MISSOULA COUNTY
INVITATION FOR BID ADDENDUM

IFB NAME: Missoula County 311 Woody St. Remodel
DUE DATE: October 8th, 2026 @ 4:00pm., Local time

ADDENDUM NUMBER: 1 **09-2026-03-A**

Attached are written questions received in response to the IFB. These questions, along with the County's responses, become an official amendment to this IFB.

1 2ND FLOOR RCP
A2.22 1/4" = 1'-0"

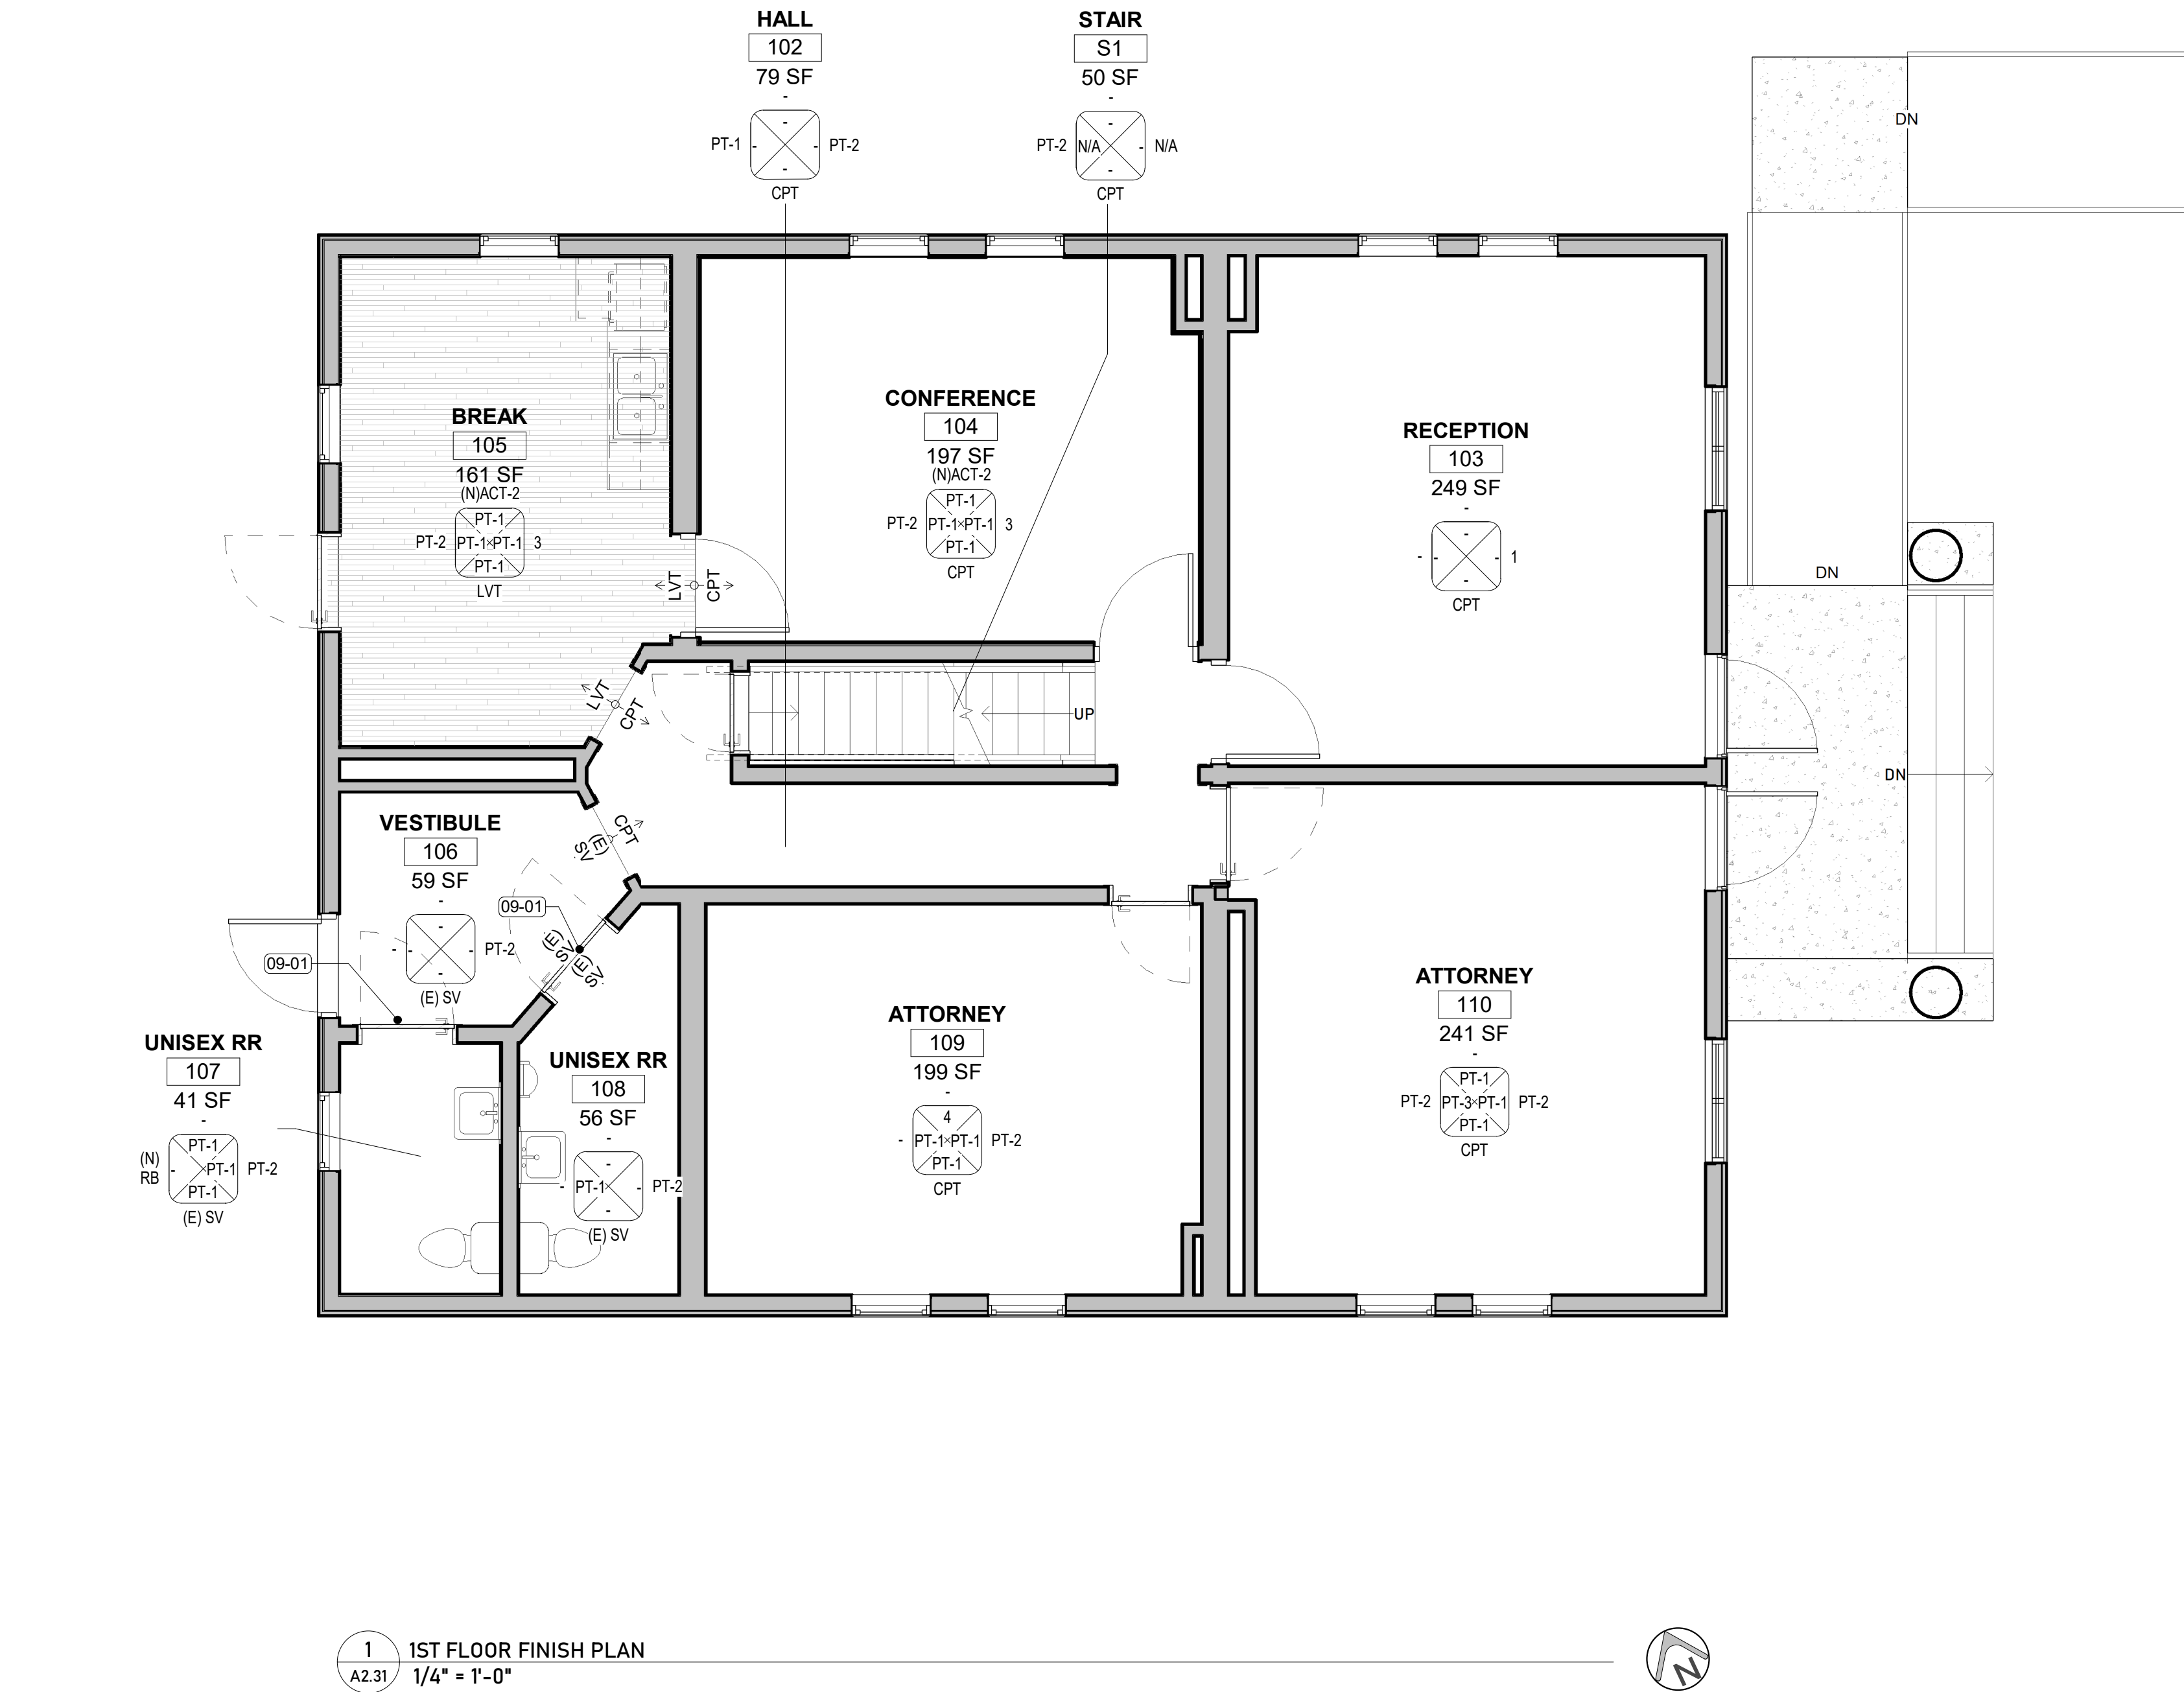
Question #4: Confirming base bid is to replace ACT ceiling in rooms 105 and 104, and ALT 2 is to replace ACT ceilings in 103, 109, 106, 107, and 108

Base bid is to replace ACT and grid in rooms 104 and 105. Bid Alternate 2 is to replace all ACT and grid in the project, including rooms on the second floor as shown on A2.22.

1 2ND FLOOR FINISH PLAN
A2.32 1/4" = 1'-0"

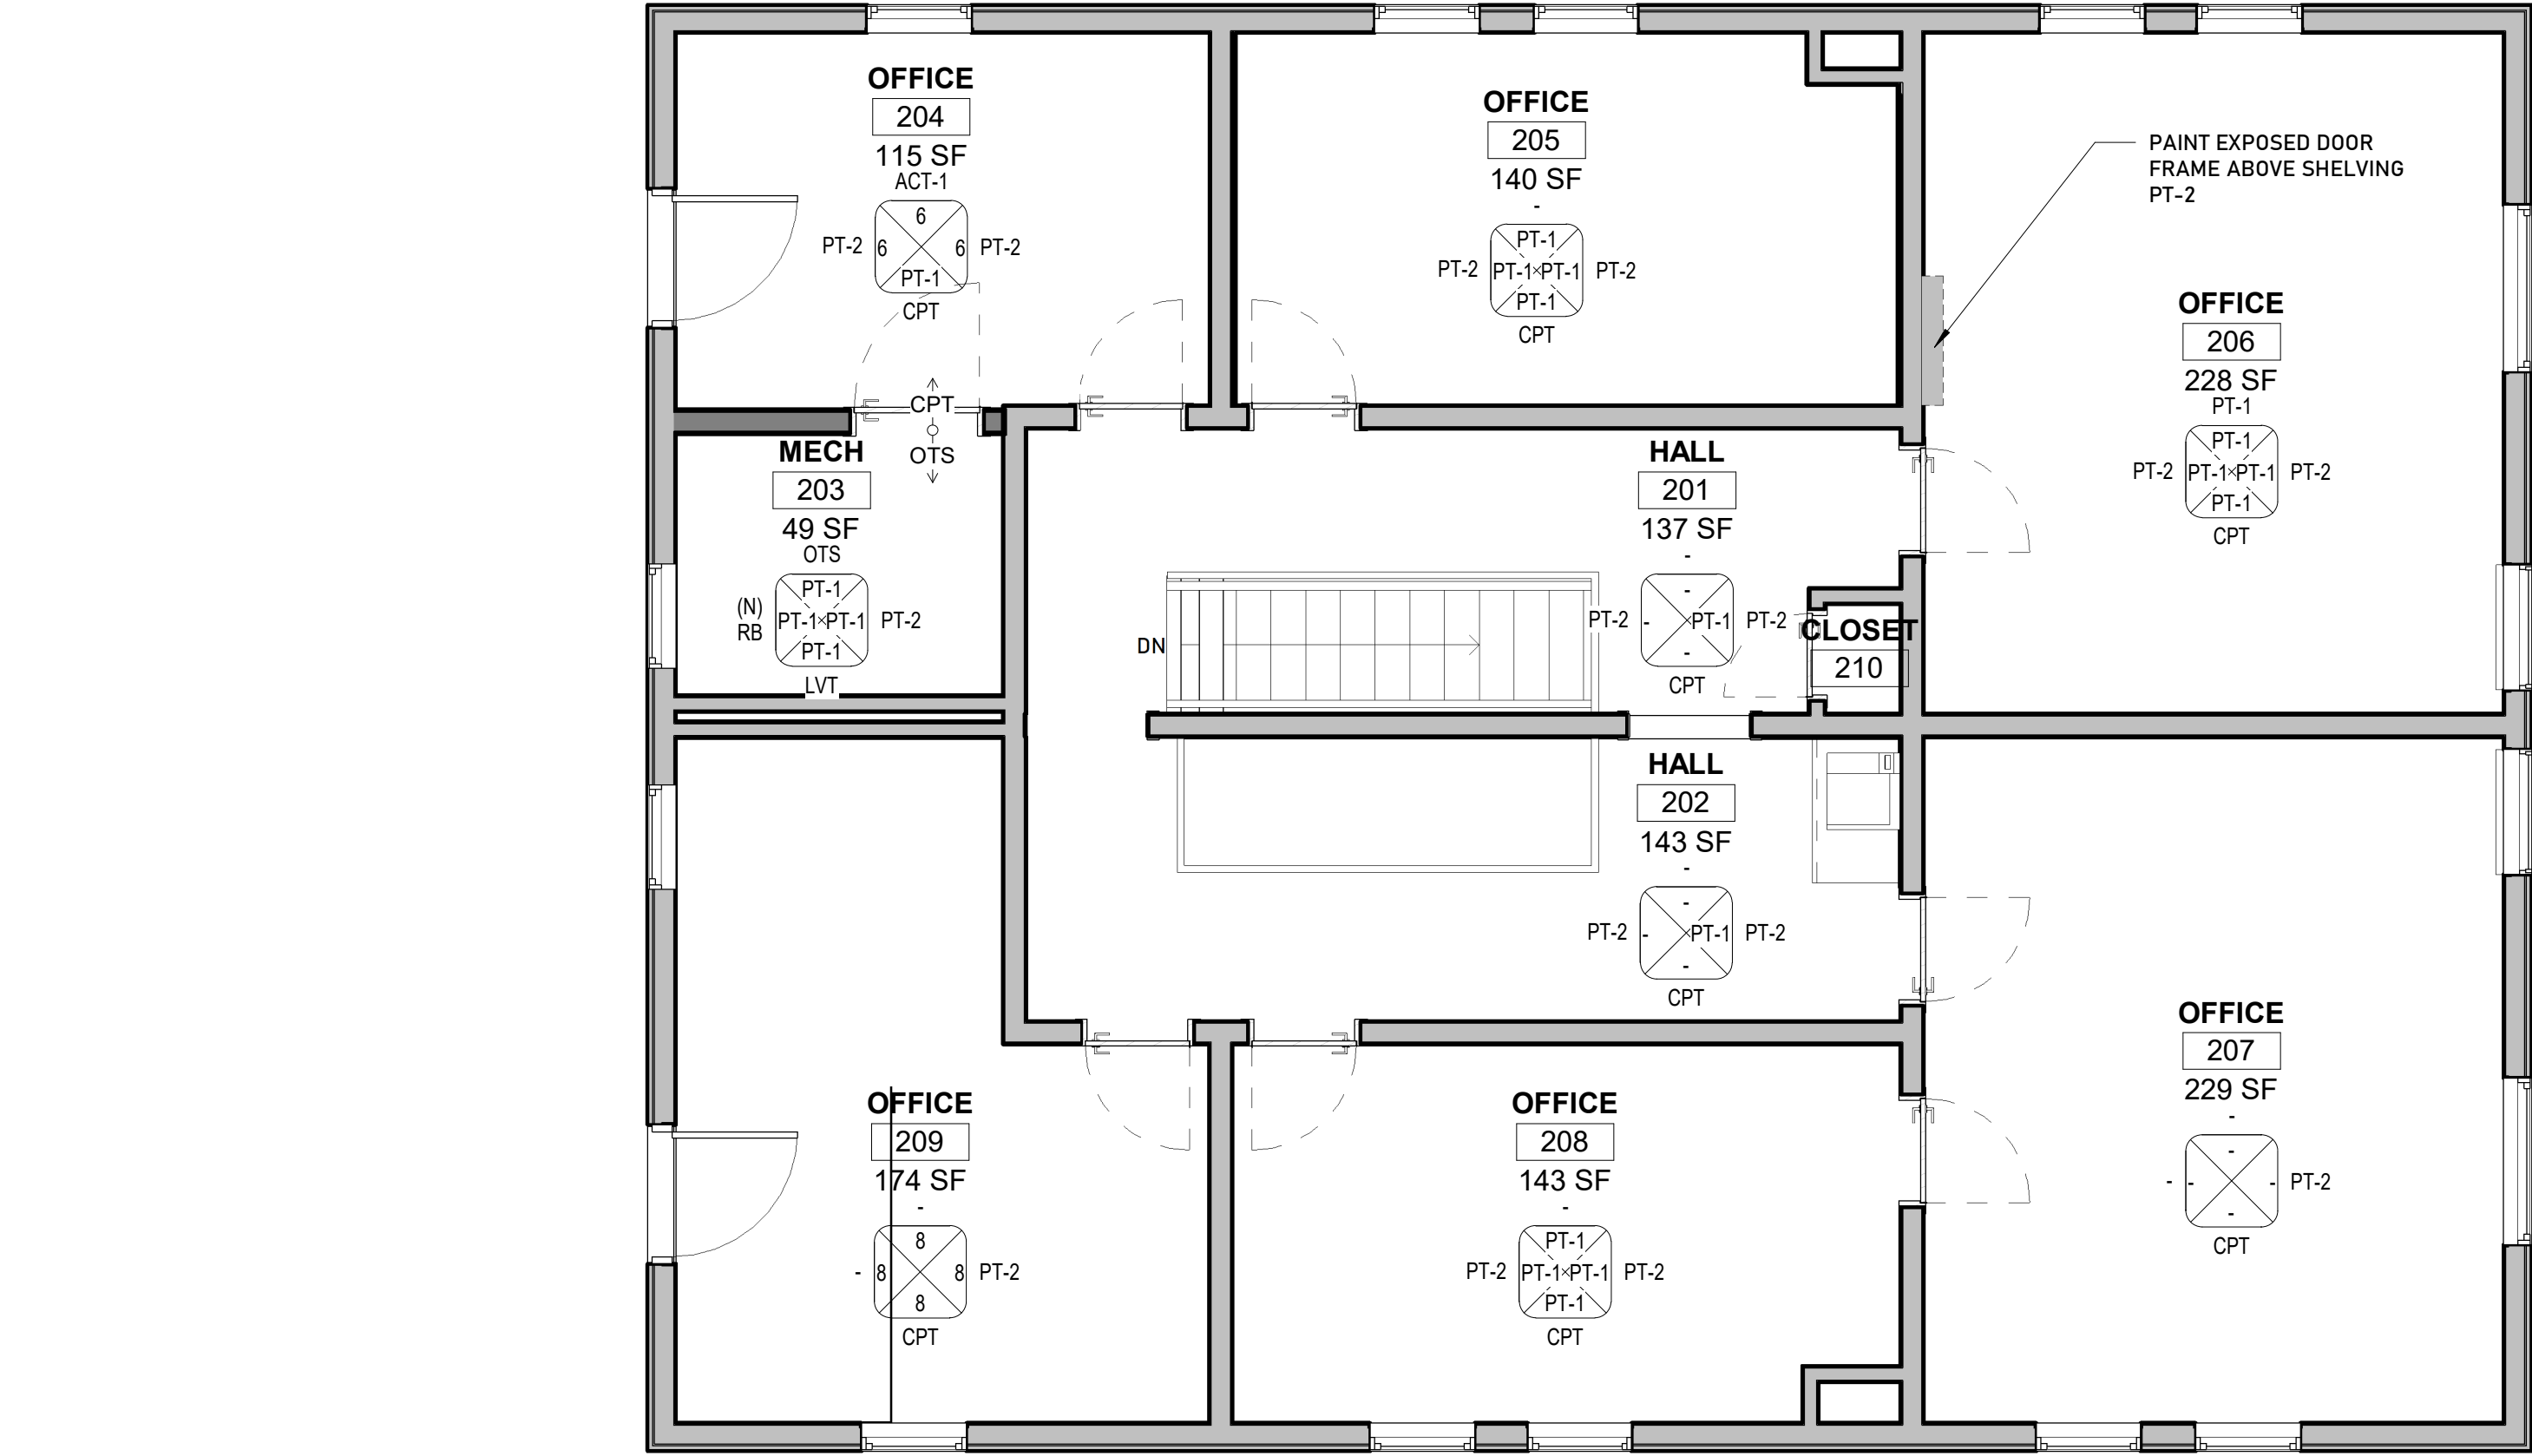
Question #14: In Mech 203, the finish schedule lists ACT-1/reconfiguration, while the reflected ceiling plan and Detail 10/A7.01 show removal and an open ceiling. Which scope controls?

The ceiling is to remain open. The finish schedule on A2.32 has been revised.
